Variations proposed under this application

Project  
60 Whitfield Street

Title  
Existing Elevation - Howland Mews

Drawing No  
60WS-A-SBA-DR-XX-4007-C3

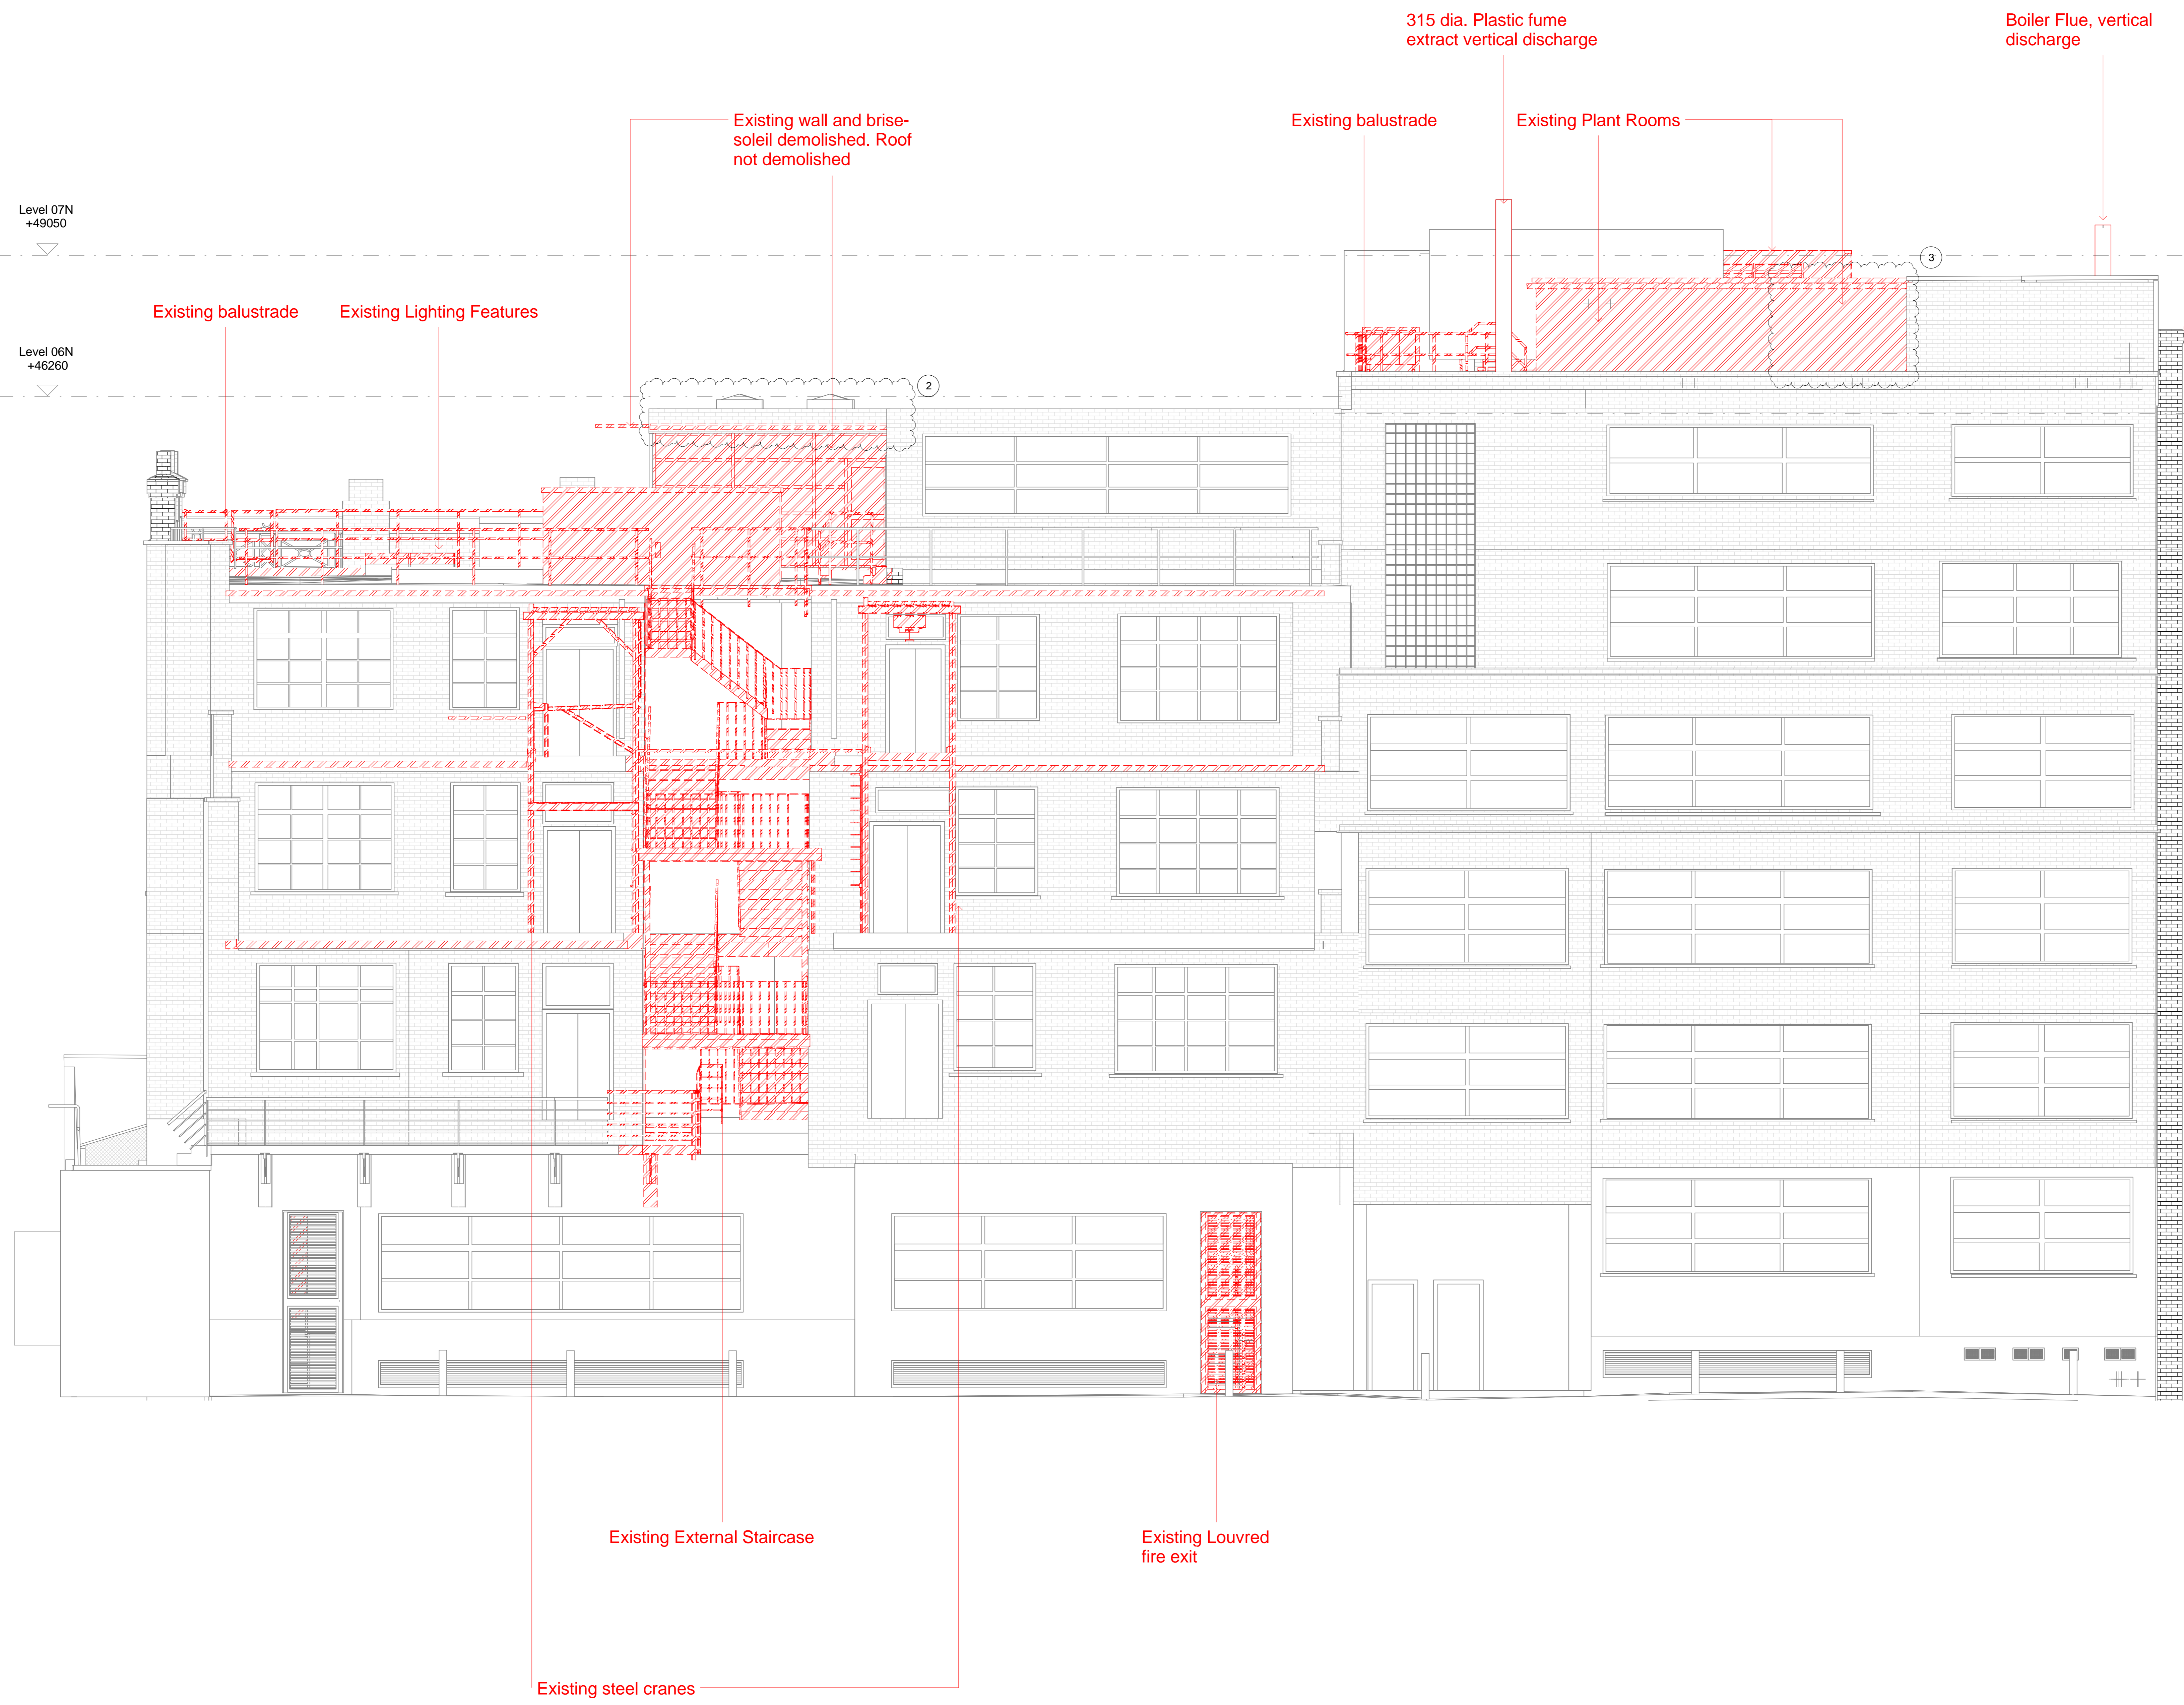
- ① Louvre added to enclose MEP
- ② Existing enclosure of Goldbeaters atrium is retained except two lateral walls
- ③ Scope of demolition of existing plant room on Walport building increased
- ④ Minor repositioning of approved flues
- ⑤ Maintenance cat ladder added to link Goldbeaters terrace with Walport terrace
- ⑥ Amended stair-landing levels
- ⑦ Parapet of dumbwaters enclosure raised by 235mm
- ⑧ Reduced louvre height to match Howland Mews elevation
- ⑨ One section of window removed
